File Nos: OP 23-05-8, SB 23-02-8 & ZN 8-23-07- Farhi Holdings Corp

Part Lot 5, Concession 12 (East Zorra), Part of Lot 1, Plan 58 - 401 Lakeview Drive, City of Woodstock

AGENCY COMMENTS- FILE OP 23-03-8, SB 23-03-8 – Farhi Holdings Corp

Plate 4: Proposed Draft Plan of Subdivision

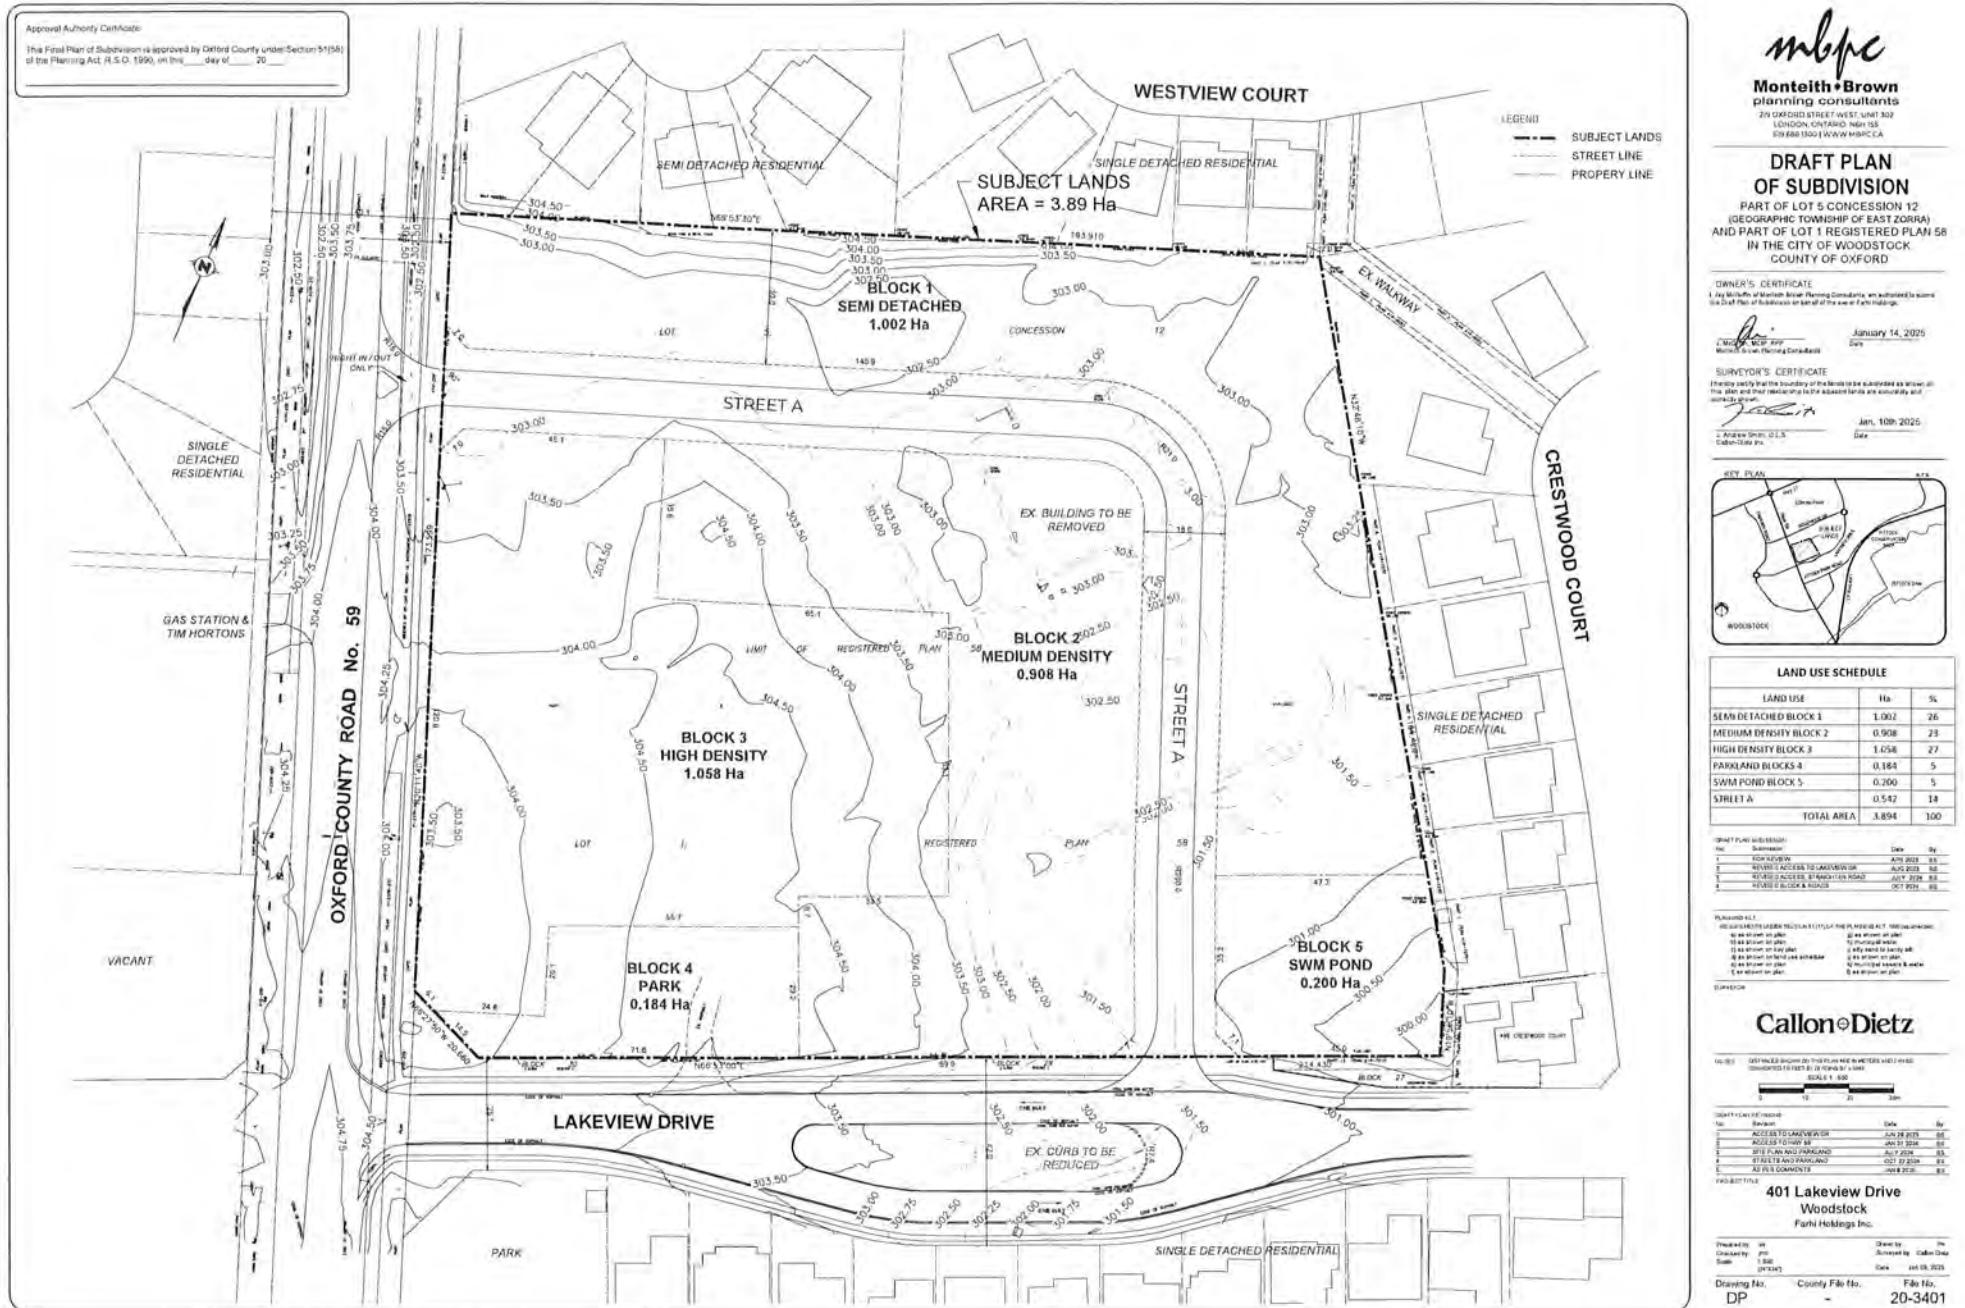
- The City only permits a maximum of 26 units on a single access.
- The City expects garbage and recycling collection will be provided as private services for the Medium and High Density blocks.
- The City recommends a qualified consultant complete a pre-condition survey on all existing structures backing onto this development.
- The developer may recommend a street name if desired for Council approval. The City also has a list of street names that are available for use.

- a. It's understood that proposed Block 2 (medium density) and Block 3 (high density) will be subject to future Site Plan Control applications/approvals.

- c. During detailed design, full water model will be required based on the above updated hydrant data. Design and modeling analysis to consider/integrate proposed water servicing design/layout/ownership/etc. for proposed Blocks 2 and 3 (ultimately subject to Site Plan approvals).

- d. As acknowledged in the FSR, watermain looping will be required. It may be worth looking into construction of a watermain from Ridgewood Dr to Street A to provide a loop, to be further assessed during detailed design.

- i. The proposed second entrance onto Vansittart Avenue as a Right-In, Right-Out (RIRO) configuration is supported by Public Works, since a second entrance is necessary to accommodate the number of units being proposed at 401 Lakeview Dr. A full movement intersection is not preferred as a second entrance; however a RIRO road access allows for emergency response, waste collection, and winter maintenance while minimizing potential operational issues associated with a full movement intersection.

#3 View Current Farhi's Application Showing one Access Oct.13,2024:

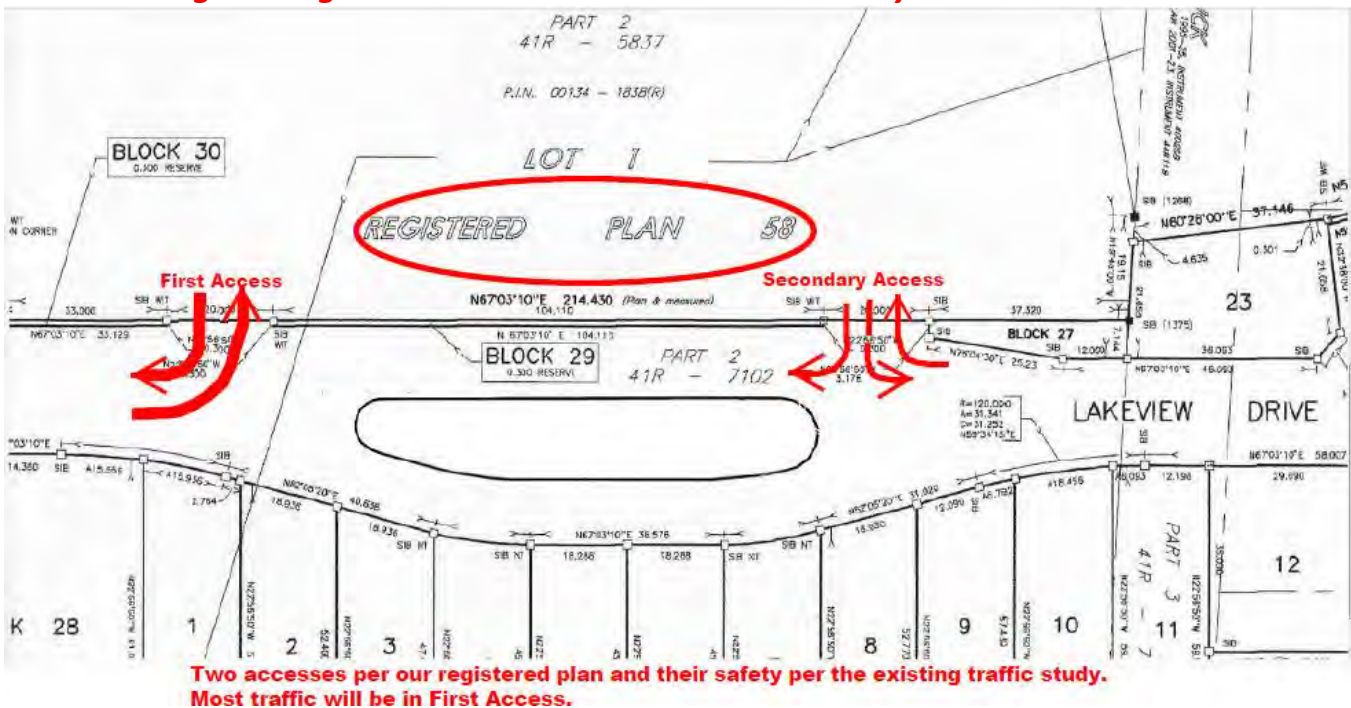
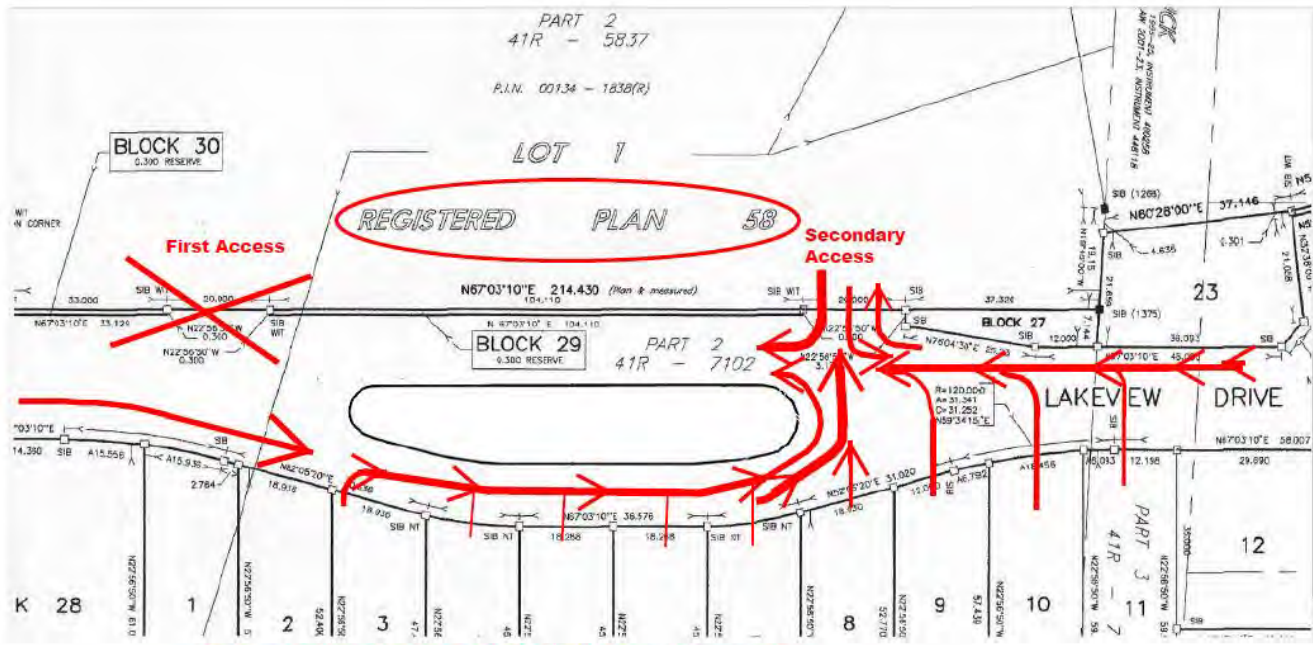
Finally, where I live 424 Lakeview Dr. looking across the street there, we face Farhi's latest revised draft plan a 4 storey, 10 stacked town houses for 20 units. It would remain an eye sore, like a wall compared to the maximum 2 storey residential Zone 1 Alder Grange subdivision along Lakeview drive. The 4 storey, 10 stacked town houses for 20 units should be replaced with maximum 2 storey residential Zone 1 or attractive townhouses maximum two stories like the rest of Lakeview Dr. See View 4. The single entrance/exit to Lakeview will be too busy, see View 3 below. The (2) 7 storey apartments building west end of Lakeview are the highest number of stories for any building north of the Thames River in Woodstock, why not 5 stories. See View 4. With all the 254 units with possible 500 cars, in addition to service vehicles, taxis and buses it will be too congested for only 1 main entrance/exit on Lakeview Dr. since almost all southbound traffic exiting on Hwy 59 will use the exit on Lakeview Dr. See View 3.

Farhi was advised by County Public Works to use the secondary east access to Lakeview Drive for any future development
